Sub: Minutes of meeting on reliability related issues of Brake system of 3-Phase Electric Locos held at RDSO on 29.11.2019

Minutes of Meeting held at RDSO on 29.11.19 on Reliability related issues of brake system for 3-Phase electric locomotive.

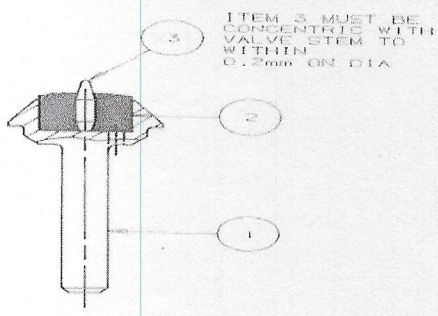
8	Limiting valve ELS/TKD also reported vide letter dated 27.08.19 leakage of limiting valve no. 79	The firm apprised that they have already provided improved valve stem to the sheds and they can provide additional valve stem as float stock if required by sheds . Sheds/ ZRs were requested to approach the firm for any further requirement. Sheds suggested that there should be some kind of marking to know in which valves this improved stem is to be provided. ELS/AQ also pointed out that in some cases of failures, they had observed that the Pin Hold provided in the pressure plate is not exactly in the center. The firm may look into the matter.	The firm apprised that Improved valve stem can be provided. As per Design, 0.2 mm concentricity to be maintained. Marking in stem is not possible but modification in stem to do stem in centre is done. Status has to be provided by Firm. 
9	CP Non Return Valve	The sheds apprises that there are failures of CP NRV especially in new locos where the screw and plate ring is coming out. The firm has upgraded to use 263 Loctite instead of 242 Loctite. However, the sheds suggested to the firm to use hex	The firm apprised that as advised by COC, proposed to use Nord Lock washer in place of multi tooth washer & Hex Bolt in place of CSK screw. Under Implementation in supplies.

bolt, spring washer and reduced thickness of plate ring in place of counter sunk screw and plate ring. This is similar to conventional loco CP NRV design that has less failures.	 <p>Fig. Nord lock washer</p>
10	Air Horn valve failures	M/s FTRTIL apprised that defective Valve Stem was measured and found that the profile was not ok. Due to this the 'O' Ring is coming out from the groove when the valve is in operation. In the Measurement report 10 degree measures 6.41 degree one side and other side is found ok. Firm replaced the machining tool and corrective action taken from 30.07.2016. Replacement are being provided to Customers. As recommended by their CoC, Material is also changed from steel to Brass.	<p>The firm apprised that material is changed from steel to Brass, replacement is under progress. It will be added in maintenance kit.</p>  <p>Fig. Brass Stem</p>
11	D2 Relay valve failures	Sheds reported Rubber seal for D2 relay valve is of 'NON-GACO' make received in 2018 is getting torn, part no 004701000A. M/s FTRTIL apprised that Pioneer Weston Seal Received 502 nos on Feb '2018 from FT UK as alternate source of Gaco, same were replaced in sheds after failures were reported. Since Gaco is going to close Alternate Source is under development. New seal will be implemented only after validation and feedback of performance from sheds. Total 8 Nos. of seal (5No.s in DBV, 2 No.s in D2 relay valve and 1 no in Brake way protection valve) fitted in ELS/AQ and performance is under monitoring. Firm is advised to provide more number of seals to other sheds for performance monitoring.	<p>The firm apprised that:</p> <ul style="list-style-type: none"> • 60 seals arranged for field Trial & given to various shed. • 20 Nos despatched to ELS/TKD and our Service Engineer in Delhi will hand over. • 20 Nos. despatched to Kolkata to hand over to ELS/Tata. • 20 Nos. despatched to Kolkata to hand over to ELS/GMO.
